CHEVRON U.S.A. INC. INTENDS TO FRAC STIMULATE THE SAN ANDRES FORMATION TO INCREASE INJECTIVITY

C. H. Lockhart Federal (NCT-1) # 8
Drinkard Field
T22S, R38E, Section 18
WBS # UWDPS-Rxxxx
Job: Frac Stimulate San Andres Formation

RE: Fracture Treat SWD – Conditions of Approval

WELL DATA SHEET

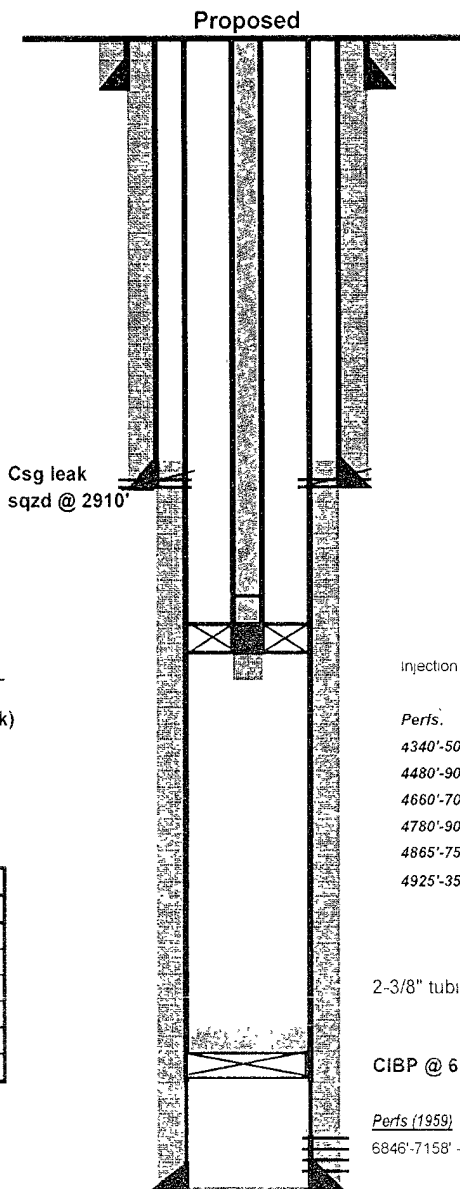
This sundry has been REJECTED for the following reasons:

1. The stability of the formation for injection is questionable since a fracture treatment is needed.
2. The risk of fractures penetrating another formation, allowing unpermitted disposal.

If continued disposal is needed in this wellbore, acidizing and/or adding more perfs within the formation would be a better alternative.
